**TXDOT AVIATION STATEWIDE AIRFIELD ELECTRICAL CONSTRUCTION PROJECT
GROUP ALPHA**

TXDOT CSJ NO.: 4222AVSAEA RE-BID

RE-BID ADDENDUM NO. 1

September 17, 2025

AIRFIELD ELECTRICAL LAYOUT PLAN

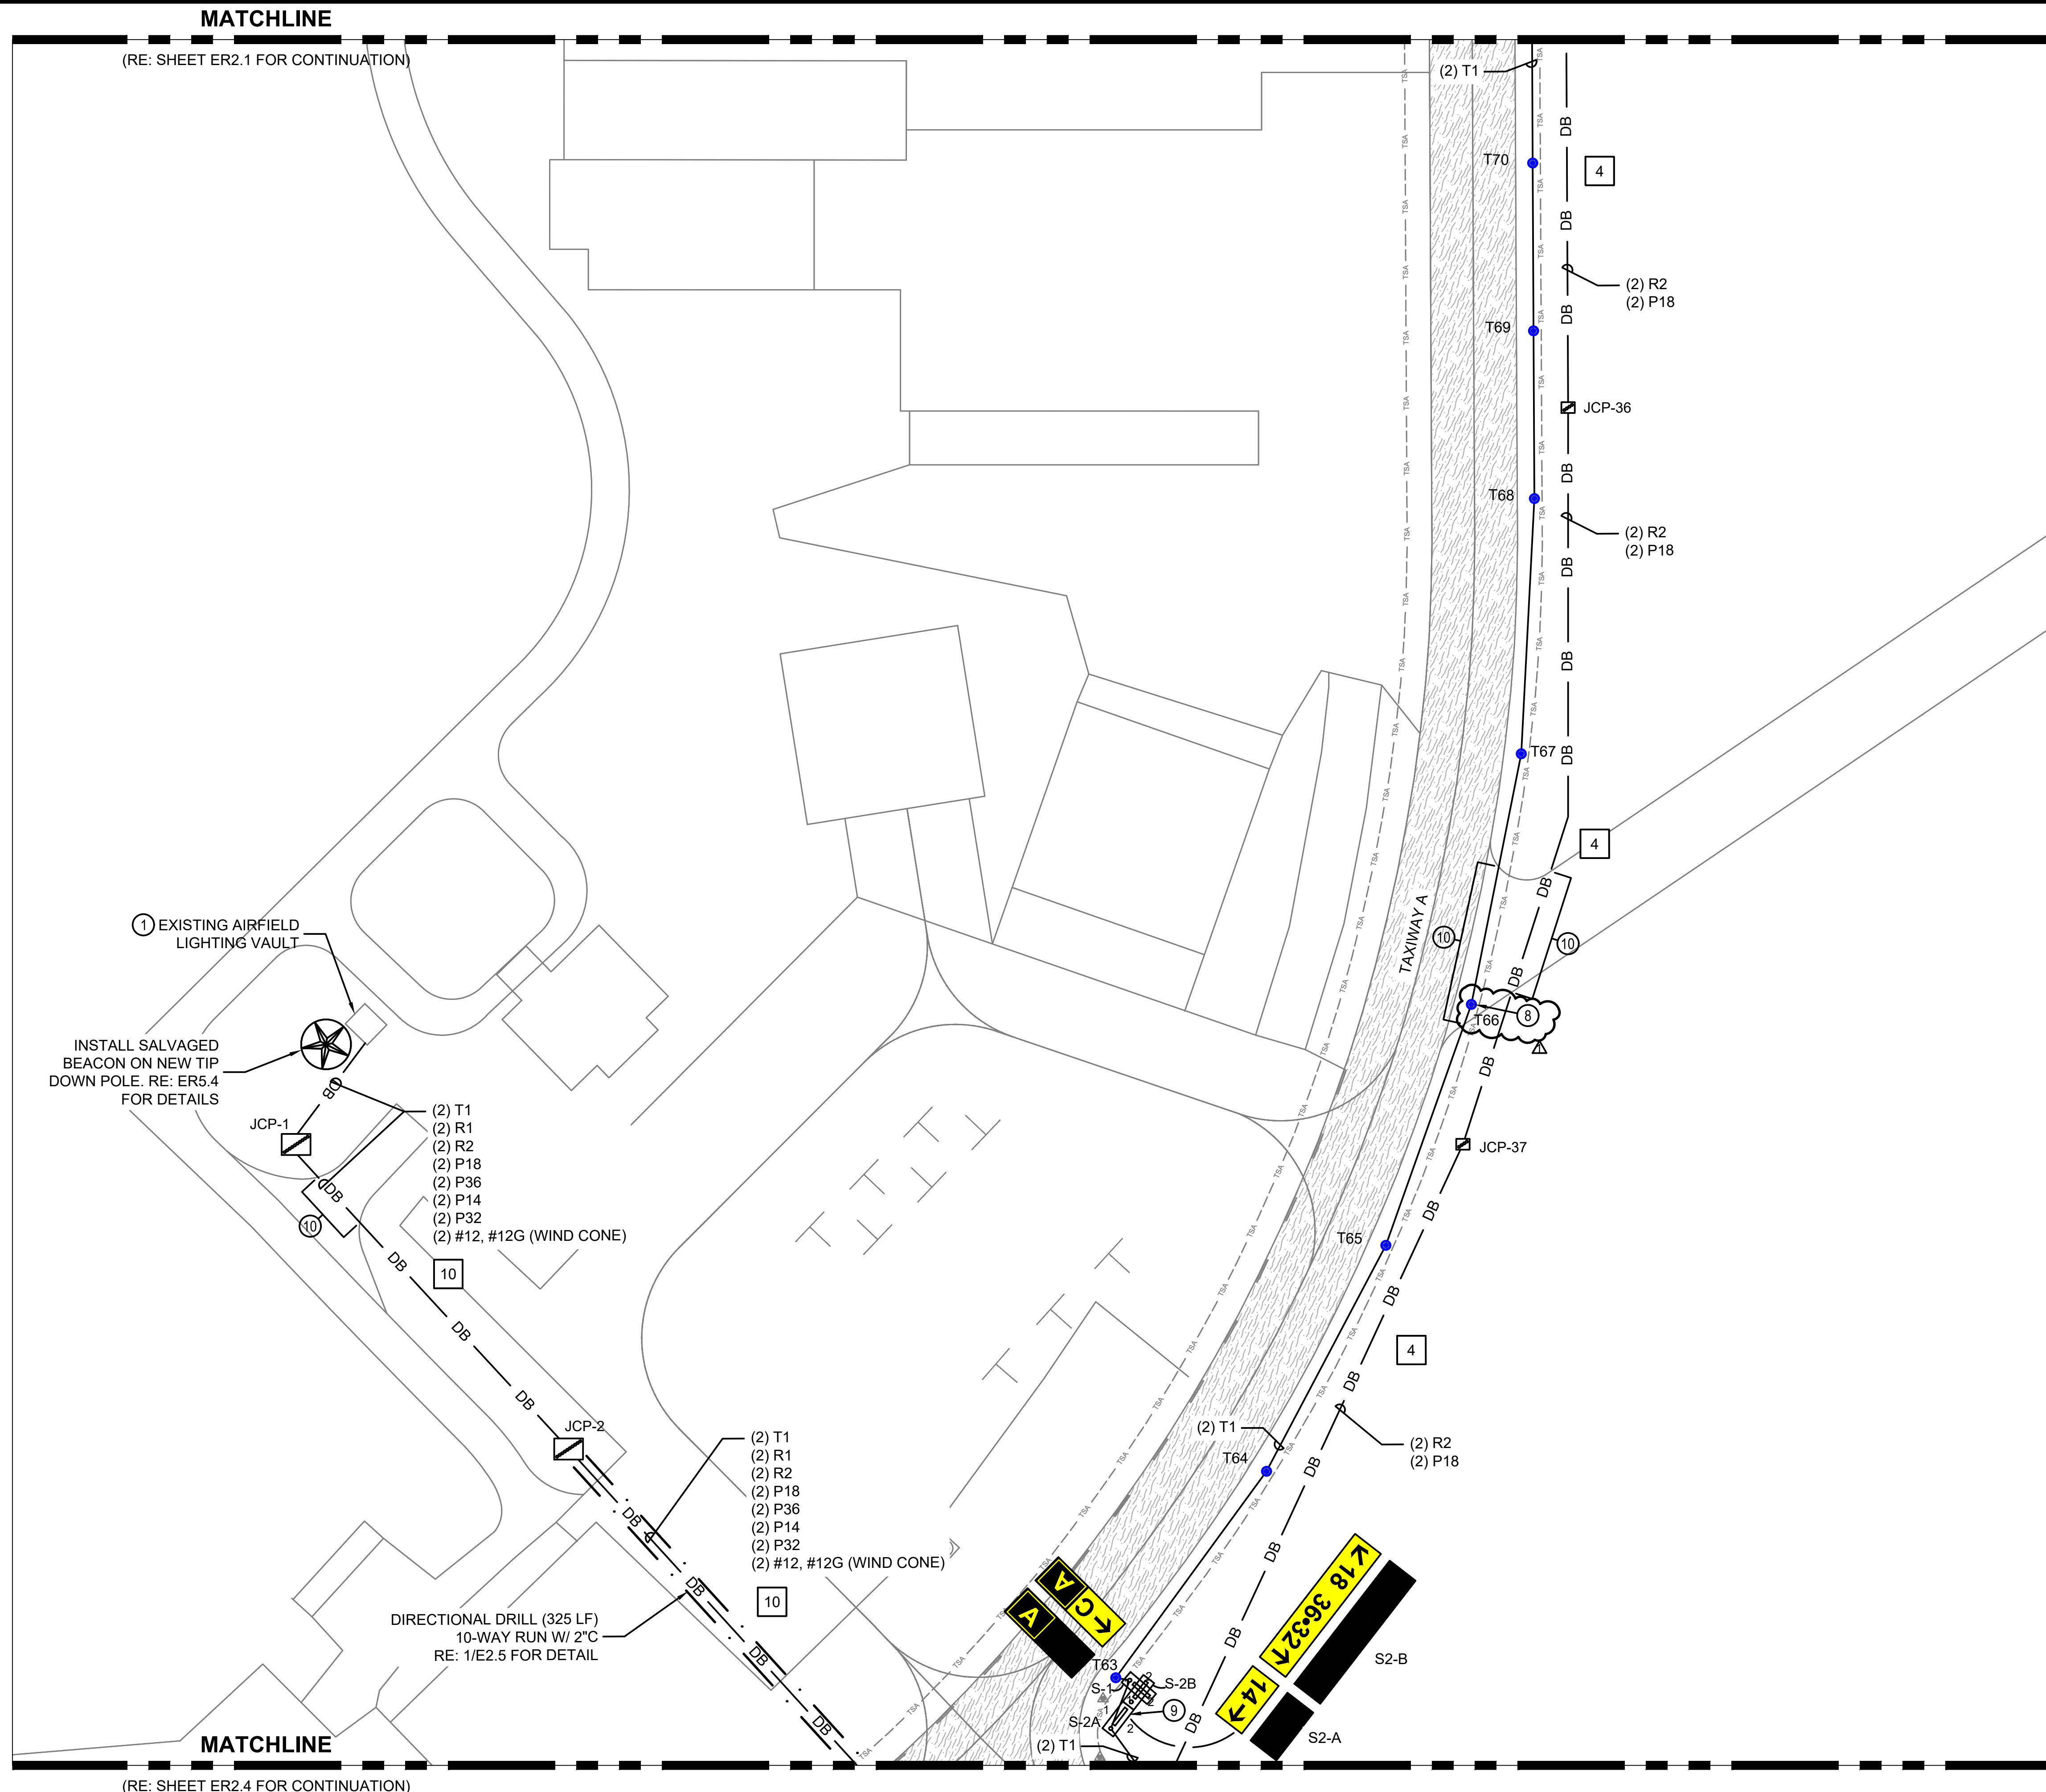
- e) **ER2.2 – Revised to clarify installation of Edge Light T66 is to be in existing pavement**
- f) **ER6.6 – Revised to reflect scope of edge light T66 being installed in existing pavement section**

12. Drawing ER2.2 (Aransas County Airport) shows approximately 75 LF of 4-Way, 2" Sch-40 PVC Conduit installed via Open Cut (per Keyed Note 10). There is no Line Item in the Bid Form for this installation.

13. Reference Drawing ER2.2 (Aransas County Airport): Please confirm if T/W Edge Light T66 is to be installed in turf (L-125-5.1) or in existing pavement (L-125-5.4)

RESPONSE: Line item L-110-5.16 has been added to account for this work.

RESPONSE: Taxiway edge light T66 is to be installed in existing pavement. This has been clarified on drawings and the quantity for this item has been updated.

ET1.2

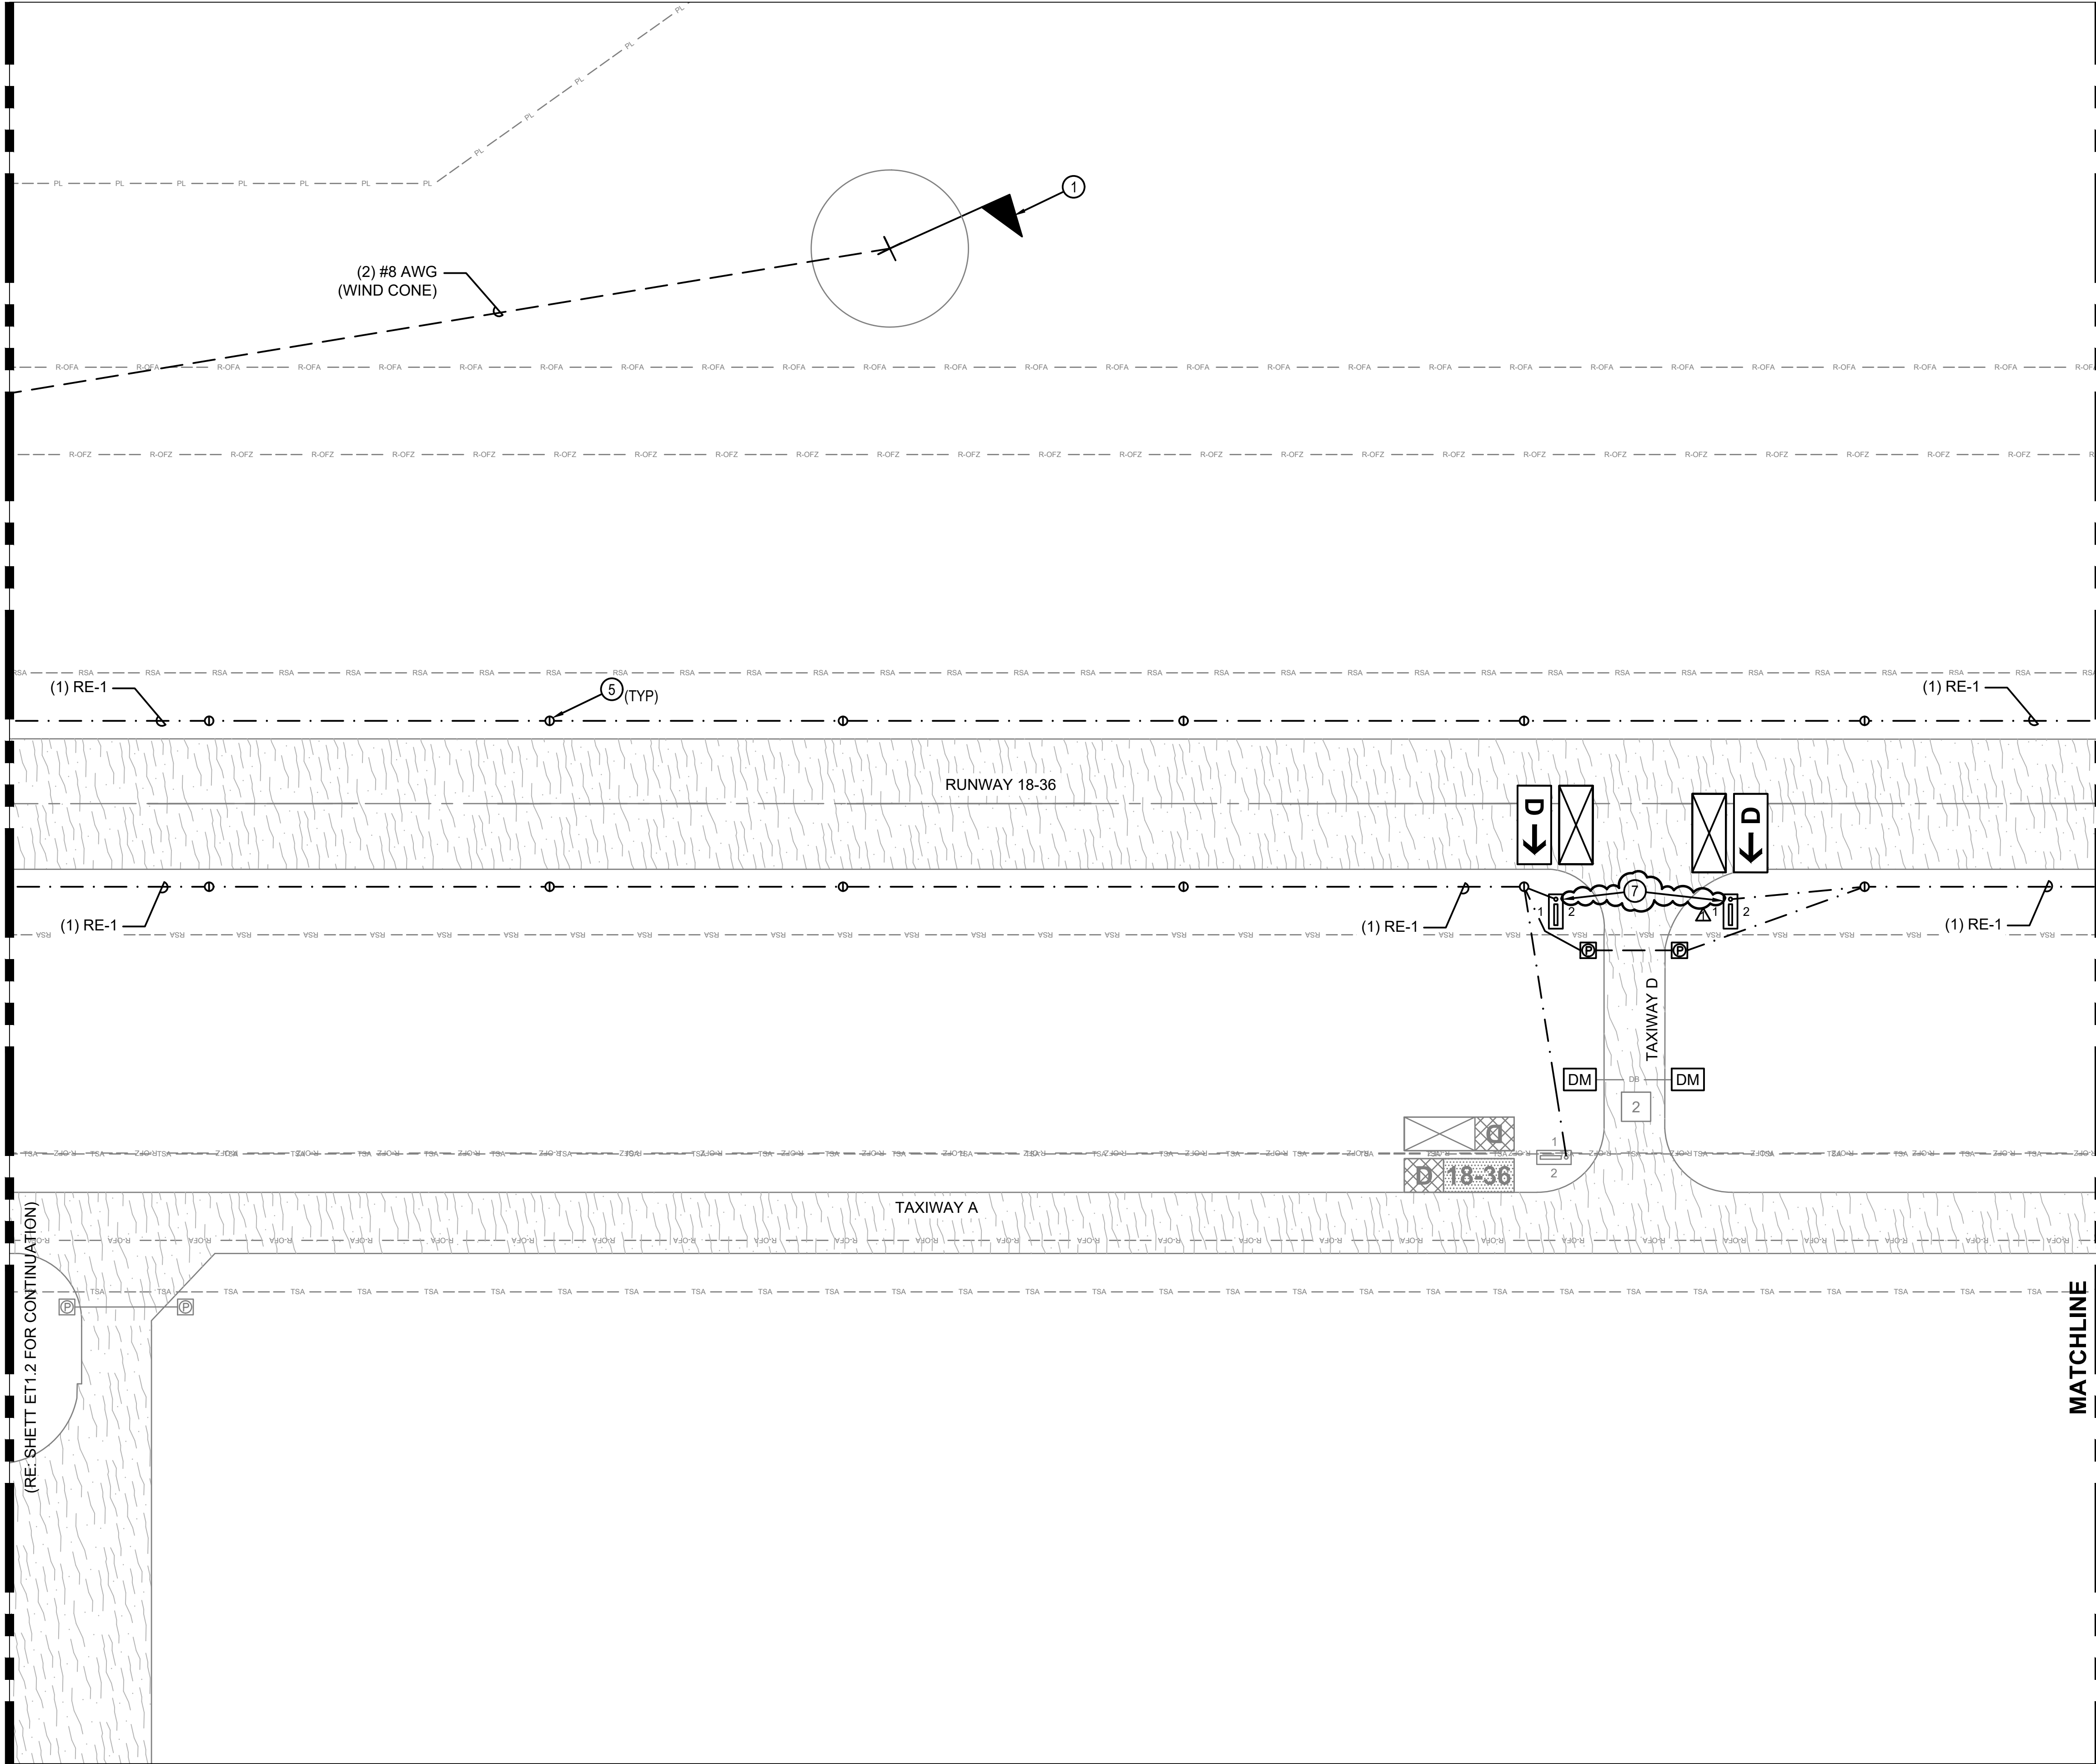
- b) **Directional drill call-outs on sheets ES2.1 and ES2.4 have been updated to reflect the correct quantity of conduits to be installed.**
- c) **Keyed note 7 has been added to sheets ET1.1, ET1.2, ET1.3, ET1.4, and ET1.5 to clarify the airfield guidance sign demolition scope.**

10. For Terrell Airport, pages ET1.1, ET1.2, ET1.3, ET1.4 & ET1.5 have airfield guidance signs to be removed. Please verify if the foundations are to remain or be removed.

RESPONSE: A keyed note has been added to the ET1 series for clarification. See updated plan sheets included in Addendum 1.
